<b>Subject:</b>  CD PLAYER DISPLAY CONCERNS	<b>Bulletin No:</b> 09-032/14
	<b>Last Issued:</b> 07/14/2014

2014 Mazda3 vehicles (with MAZDA CONNECT and CD player) with VINS lower than JM1BM\*\*\*\* \*\* 154022 (produced before December 01, 2013)

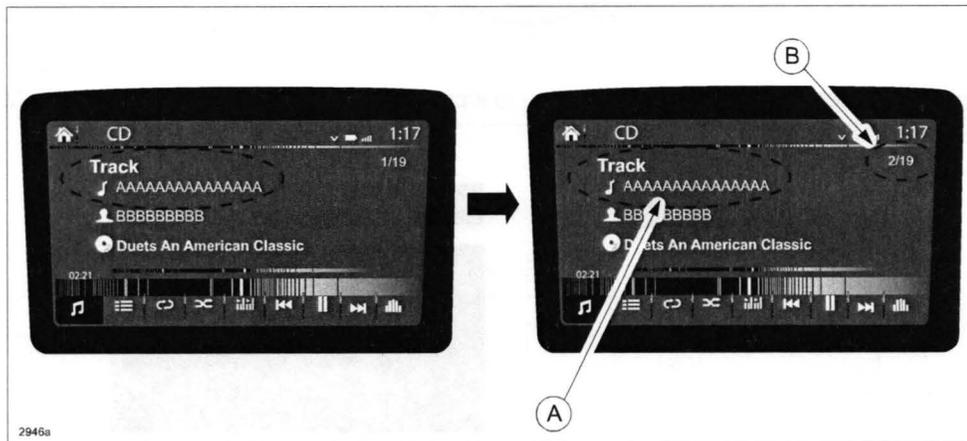
Symptom 1: The song title on the CD display (A) does not change when it goes to the next song. However, the track number (B) changes

Symptom 2: The track list does not open after inserting the CD, but the "Disc loading" appears on the display.

This is caused by improper software of the CD player. The software of CD player has now been changed to correct this issue.

Customers having this concern should have their vehicle repaired using the following repair procedure.
